SUBJECT: *see rpt* Forwards proprietary & nonproprietary structural audit open issue close out info. Affidavit requesting proprietary status for info encl. Proprietary info withheld.

RE: Nine Mile Point Unit 2  
Docket No. 50-410

Enclosed for your review are eight copies of information to close out certain open issues of the NRC Structural Audit. During the Structural Audit of December 12 through 16, 1983 we committed to provide this information.

ATTACHMENT A

# NELSON STUDS FOR SECURING CRANE RAILS

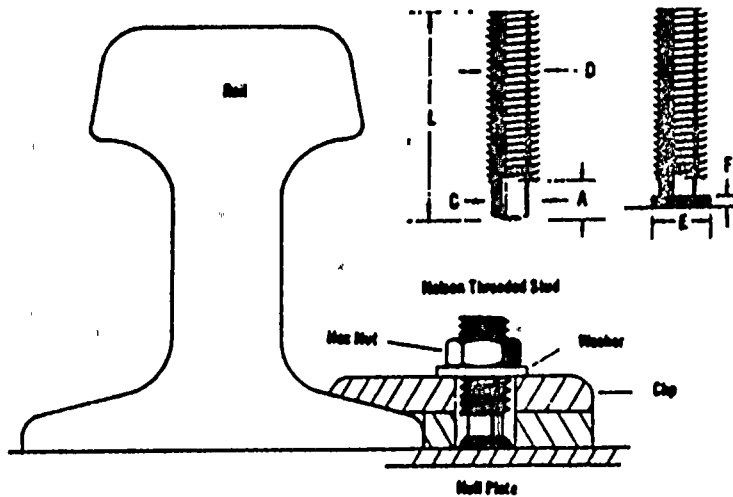
Provide data on strength, material type, and mechanical properties of Nelson studs used in NMP2 polar crane rail support design.

Nelson studs Type CPL, 7/8-inch diameter threaded studs are used in fastening polar crane rail supports. This method of fastening offers easy installation, reduced maintenance, and added safety during installation and operation. The attachment provides the data on material composition, type, strength, etc, from the catalog, Nelson - Construction Applications in Power Generating Plants by (TRW - Nelson Division).
